# **GOVERNMENT SUBMISSIONS**

## 6 Government submissions

This chapter provides responses to issues raised by government agencies and local councils.

**Figure 6-1 Performance of a station at Alexandria**

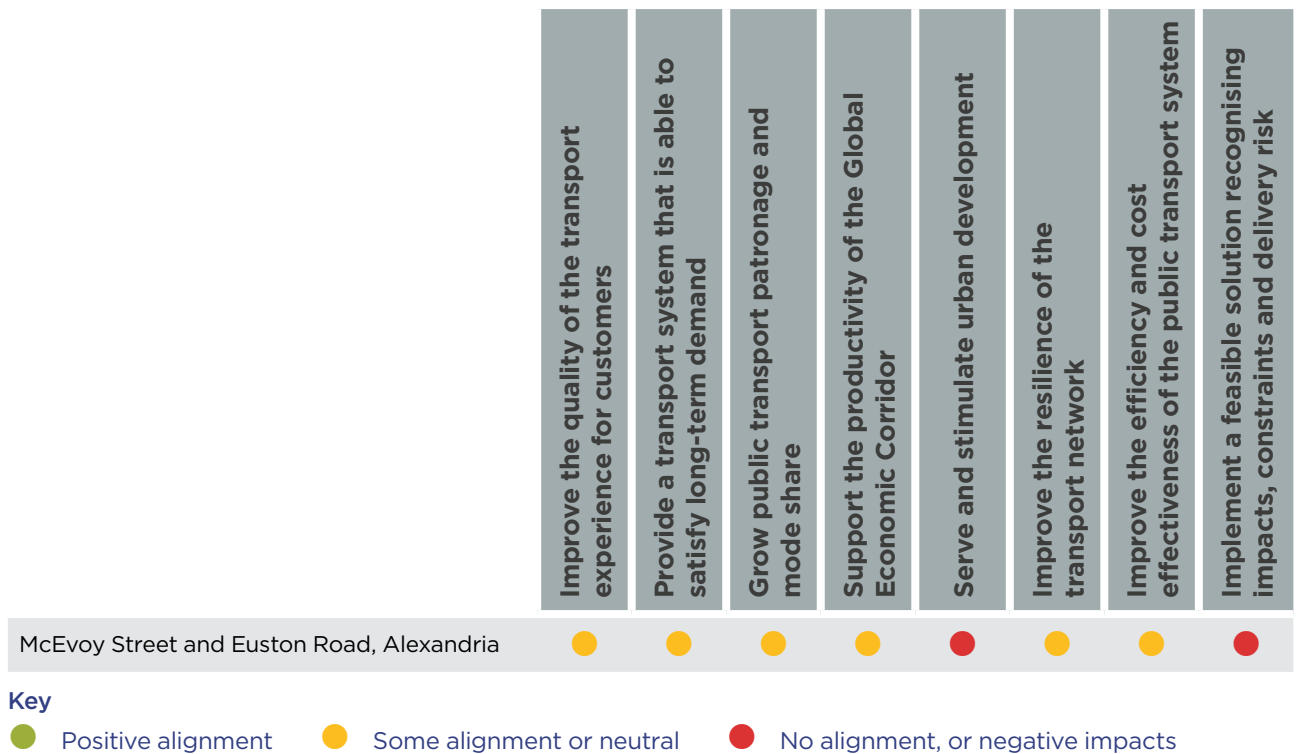
In response to the submission from the City of Sydney, a further Strategic Merit Test has been conducted to investigate the opportunity for an additional metro station near the junction of McEvoy Street and Euston Road, Alexandria. A station at this location would serve a predominantly residential catchment with some mixed use developments and provide a new connection to the City of Sydney's Southern Employment Lands. It would have some overlapping catchments with Green Square Station, Erskineville Station and the new Waterloo Metro station, so would serve a partial new rail catchment. The size of the new catchment is relatively small and contains very limited potential for employment and population growth.

As demonstrated in Figure 6-1, this station location at Alexandria performed similarly to the Strategic Merit Test results of a metro station location at Ashmore, Australian Technology Park, Erskineville, Newtown, Redfern, St Peters and Wilson Street (Eveleigh) (as referred to in Section 4.4.3 of the Environmental Impact Statement).

In response to the objective noted in the table above to ‘improve the resilience of the transport network’, analysis of Erskineville Station patronage in 2014 found that customers can experience train loading of above 135 per cent, which is the benchmark beyond which passengers start to experience crowding and dwell times can impact on-time running. However, it was one of the lower patronised stations on the Sydney Trains network (ranked 118th) with the average number of customers using Erskineville Station during the morning 3.5 hour AM peak period was 1,360 (entries and exits). A station in Alexandria may attract customers from Erskineville Station; however the number of customers would not be high.

**Figure 6-2 Performance of a station at Alexandria**

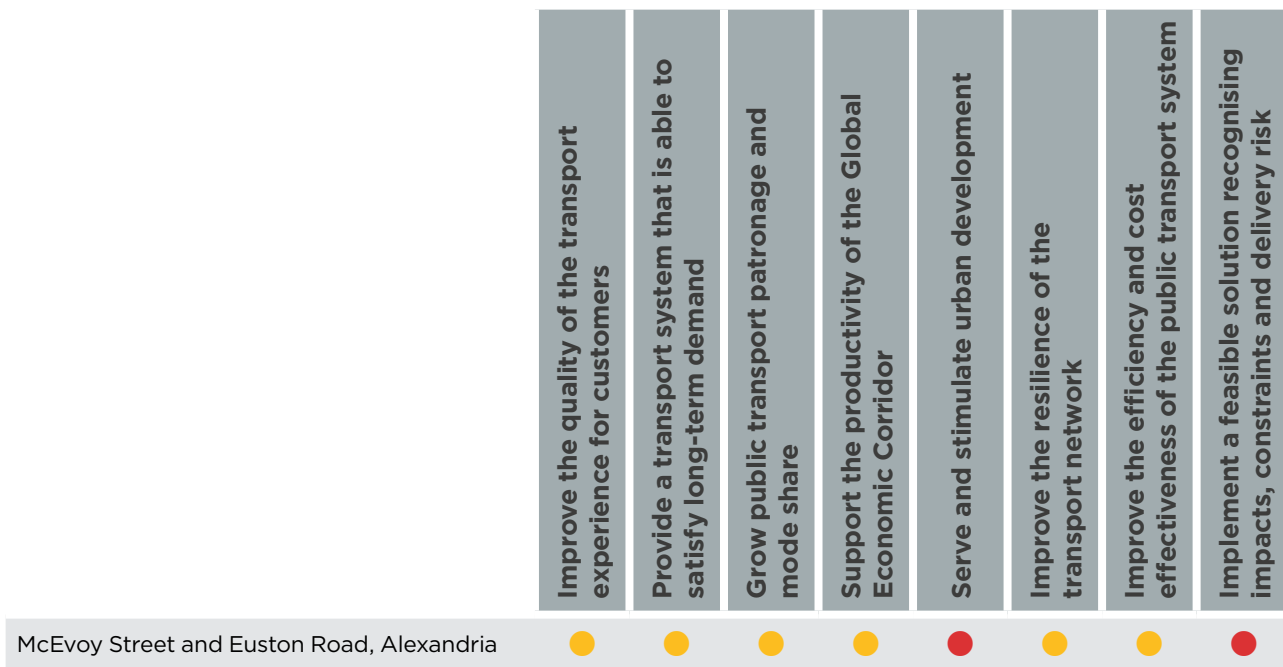
Planning for urban renewal in the South Sydney area predates the proposed Sydney Metro City & Southwest. Masterplanning for the area has been led by the City of Sydney and has included detailed technical studies, including traffic and parking studies. In particular, an Infrastructure Plan identifies the strategic infrastructure requirements to support development of the Ashmore precinct.

During the development stage of the Sydney Metro City & Southwest, consideration was given to opportunities to improve transport accessibility, consistent with the Department of Planning and Environment's *A Plan for Growing Sydney* and UrbanGrowth NSW's Central to Eveleigh Urban Transformation and Transport Program. During this stage, the opportunity to include an additional station between Central and Sydenham was subject of a strategic evaluation of station locations.

The evaluation subjected the Sydney Metro City & Southwest to a Strategic Merit Test. A Strategic Merit Test is used to quantify expected broad benefits of a transport option against project objectives. As part of the Strategic Merit Test, Sydney Metro investigated a number of station locations between Central and Sydenham.

A range of station locations in the South Sydney area were evaluated against the project objectives. The locations included at the Australian Technology Park, Waterloo, McEvoy Street, Green Square, Erskineville, Ashmore, and St Peters. The evaluation results are provided in Section 4.4.3 of the Environmental Impact Statement. In summary, where there is an existing rail station, or the potential station location is within close proximity to an existing station there would be limited increase in rail catchment, limited change to public transport from private vehicles and no significant relief to existing public transport services.

As demonstrated in Figure 6-2, this station location at Alexandria performed similarly to the Strategic Merit Test results of a metro station location at Ashmore, Australian Technology Park, Erskineville, Newtown, Redfern, St Peters and Wilson Street (Eveleigh) (as referred to in Section 4.4.3 of the Environmental Impact Statement).
